ENGINEERING SERVICES SPATIALS

47359_ESP_01 - 461 Chapel Road, Bankstown

Date 23.01.2025 - Revision 1

PROJECT
**461 CHAPEL ROAD, BANKSTOWN, NSW
 2200**
 DRAWING TITLE
**ENGINEERING SERVICES SPATIALS -
 BASEMENT**

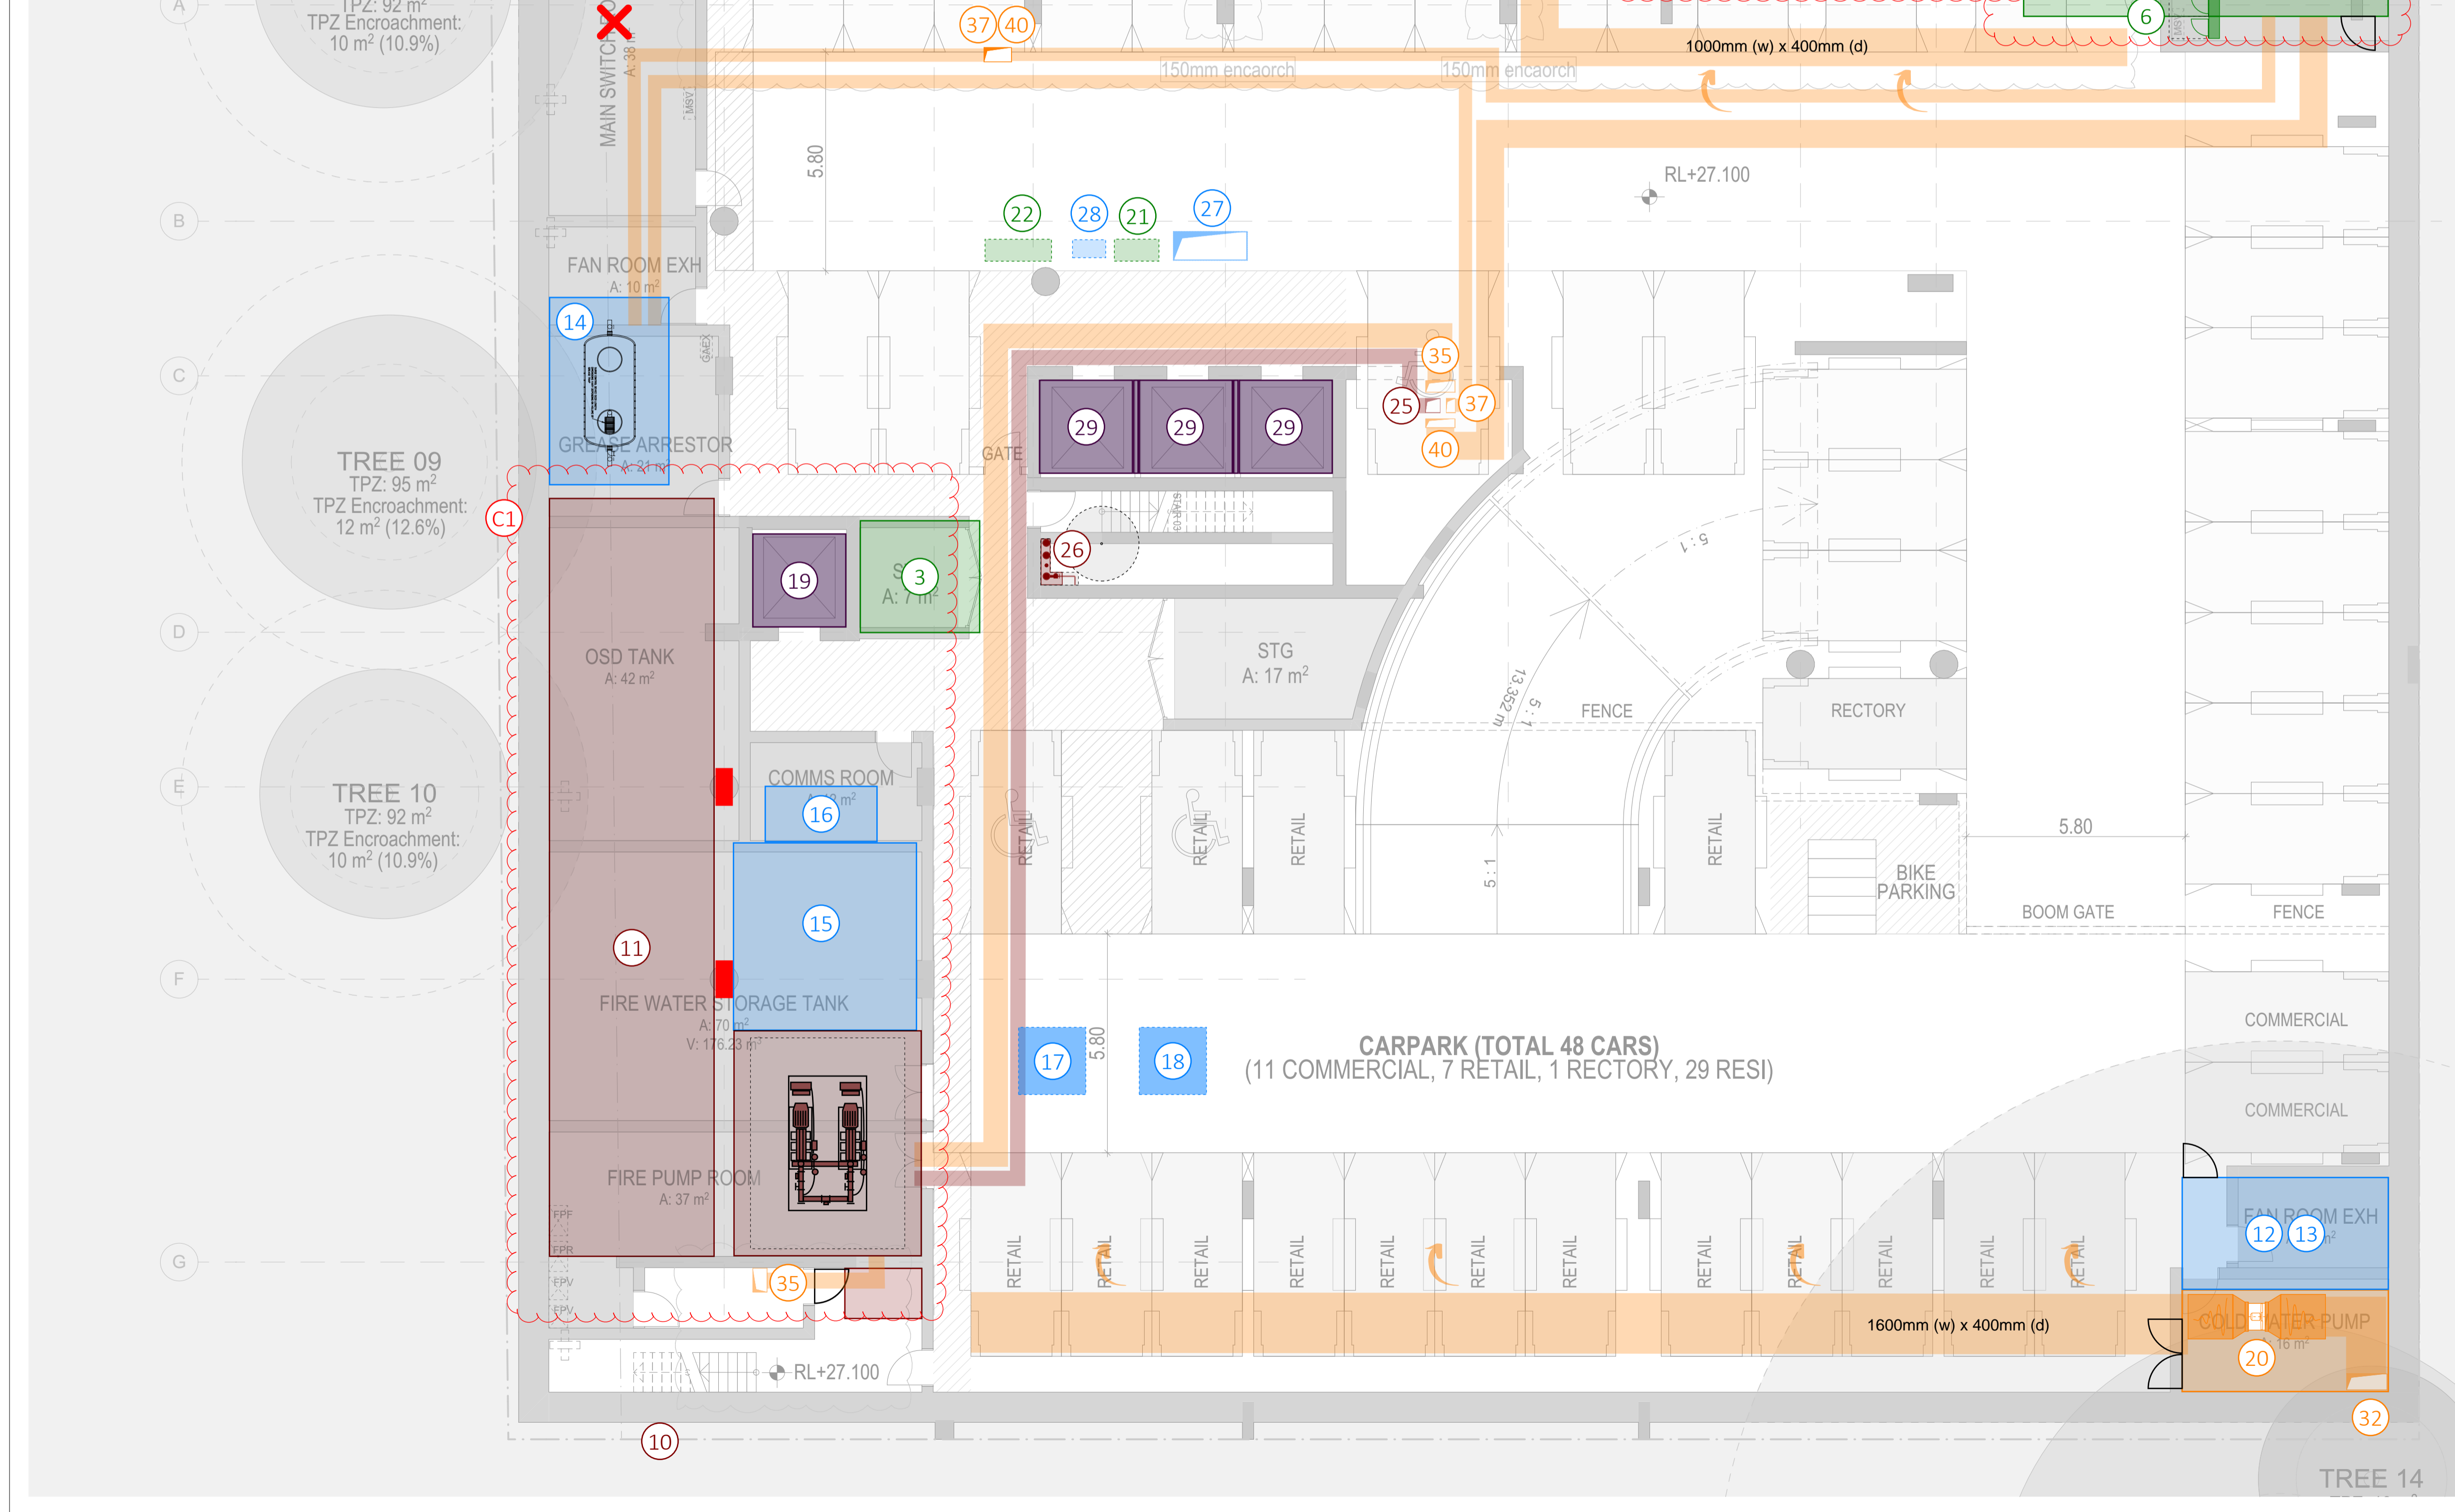
Action Reference No.	Action	Issue Status
C1	Egress around fire tanks is under review. Columns to be revised as indicated. We recommend relocating the OSD tank to allow for the fire tank arrangement as shown.	Open
C2	Columns in switch room to be reviewed. If columns need to remain, the switch room may need to get deeper.	Open
C3	Egress design compliance to be confirmed. We recommend having a direct egress path to the fire control room from outside, to be confirmed by BCA.	Open
C4	We recommend allowing for traffic bollards around the substation due to the proximity to the vehicle travel path.	Open
C5	Carpark exhaust fans to be located at high level. To be coordinated with waste room layout and garbage chute locations.	Open
C6	Stair pressurisation fans to be stacked as shown.	Open
C7	Carpark intake to be coordinated with landscaping in communal outdoor space.	Open
C8	Plant to be reviewed by acoustics to determine acoustic treatment required for space. Intent for plant space to be open to above to allow for ventilation to plant.	Open

C9	Access to roof to have integrated ladder complete with handrail. We recommend egress paths to rooftop to be reviewed by BCA.	Open
C10	No built form is permitted above kiosk substations. To retain substations as kiosk type, extent of building to be reviewed.	Open
C11	900mm clear trench is required below the kiosk to allow for HV feeder from authority connection, and between kiosk and main switch room. This will result in a low head height area as shown.	Open
C12	Cupboards are required to transition on level to connect to basement level. Transition and riser location to be coordinated with architecture	Open
C13	Anything within the 3m radius of the kiosk substations is required to be blast proof. Location and extent of roller shutter door to be reviewed to ensure this is not within the blast radius.	Open

PROJECT
461 CHAPEL ROAD, BANKSTOWN, NSW 2200
 DRAWING TITLE
ENGINEERING SERVICES SPATIALS - LEVEL 03-07

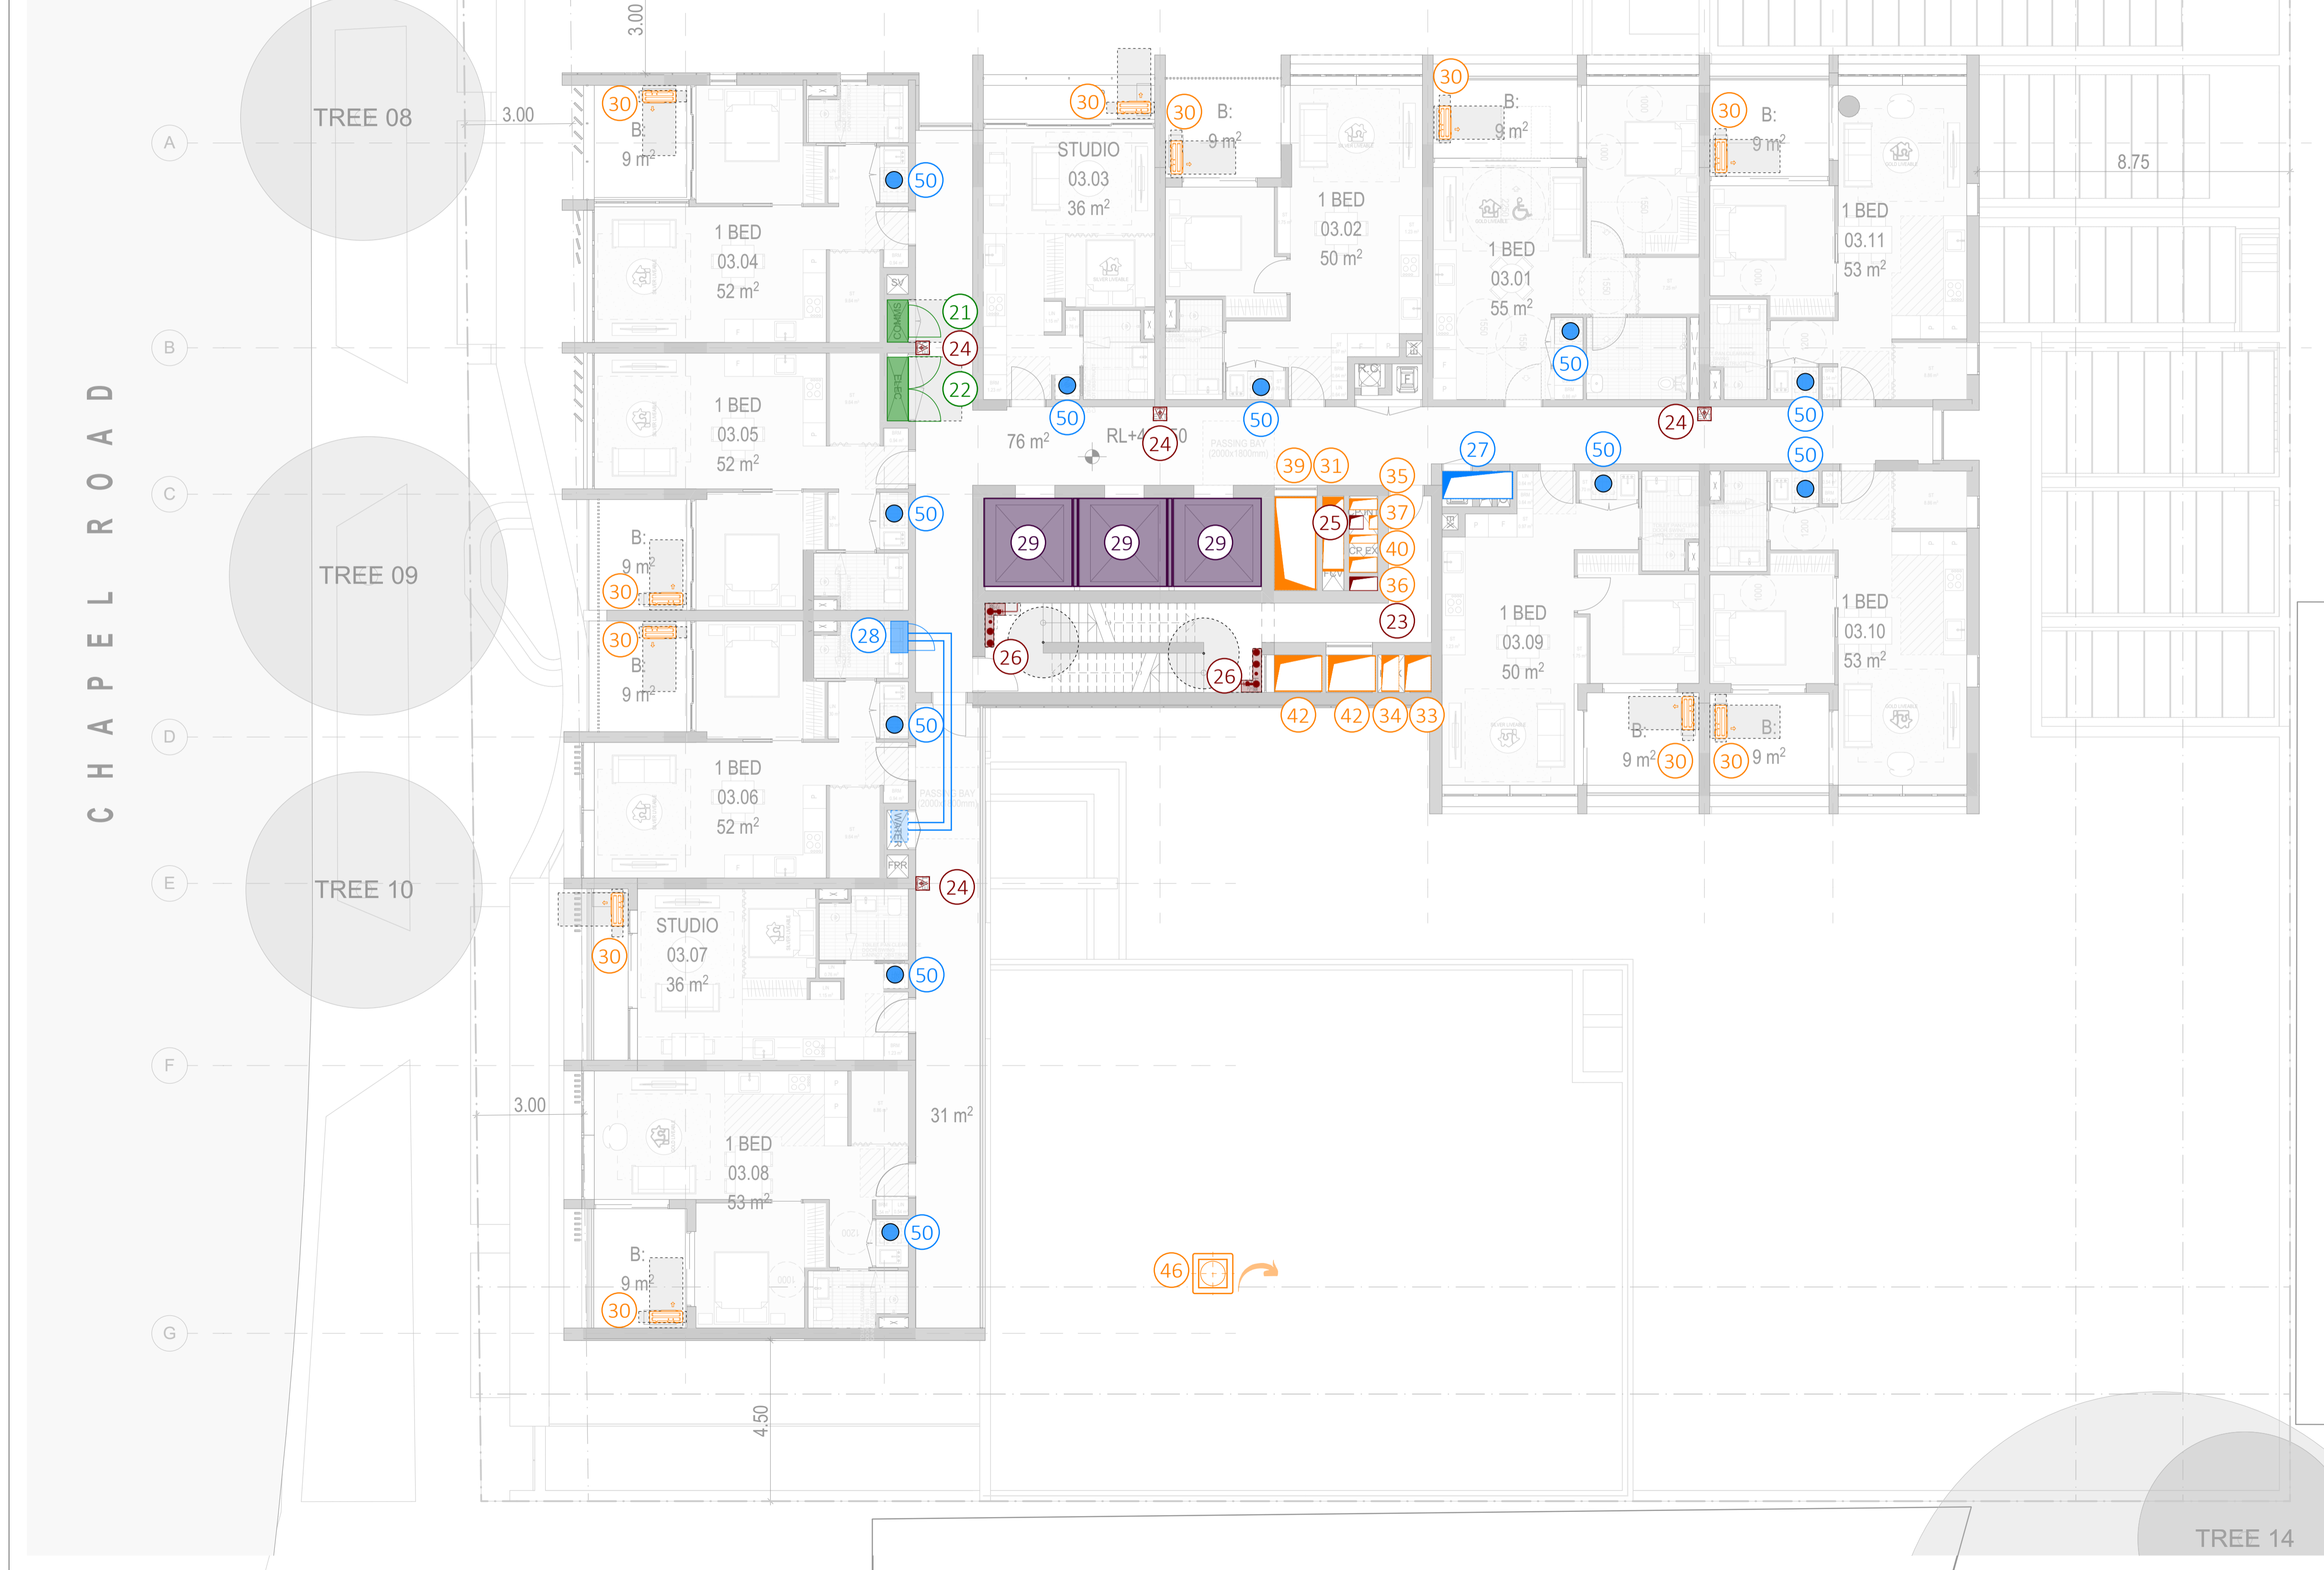
Action Reference No.	Action	Issue Status
C1	Egress around fire tanks is under review. Columns to be revised as indicated. We recommend relocating the OSD tank to allow for the fire tank arrangement as shown.	Open
C2	Columns in switch room to be reviewed. If columns need to remain, the switch room may need to get deeper.	Open
C3	Egress design compliance to be confirmed. We recommend having a direct egress path to the fire control room from outside, to be confirmed by BCA.	Open
C4	We recommend allowing for traffic bollards around the substation due to the proximity to the vehicle travel path.	Open
C5	Carpark exhaust fans to be located at high level. To be coordinated with waste room layout and garbage chute locations.	Open
C6	Stair pressurisation fans to be stacked as shown.	Open
C7	Carpark intake to be coordinated with landscaping in communal outdoor space.	Open
C8	Plant to be reviewed by acoustics to determine acoustic treatment required for space. Intent for plant space to be open to above to allow for ventilation to plant.	Open

C9	Access to roof to have integrated ladder complete with handrail. We recommend egress paths to rooftop to be reviewed by BCA.	Open
C10	No built form is permitted above kiosk substations. To retain substations as kiosk type, extent of building to be reviewed.	Open
C11	900mm clear trench is required below the kiosk to allow for HV feeder from authority connection, and between kiosk and main switch room. This will result in a low head height area as shown.	Open
C12	Cupboards are required to transition on level to connect to basement level. Transition and riser location to be coordinated with architecture	Open
C13	Anything within the 3m radius of the kiosk substations is required to be blast proof. Location and extent of roller shutter door to be reviewed to ensure this is not within the blast radius.	Open
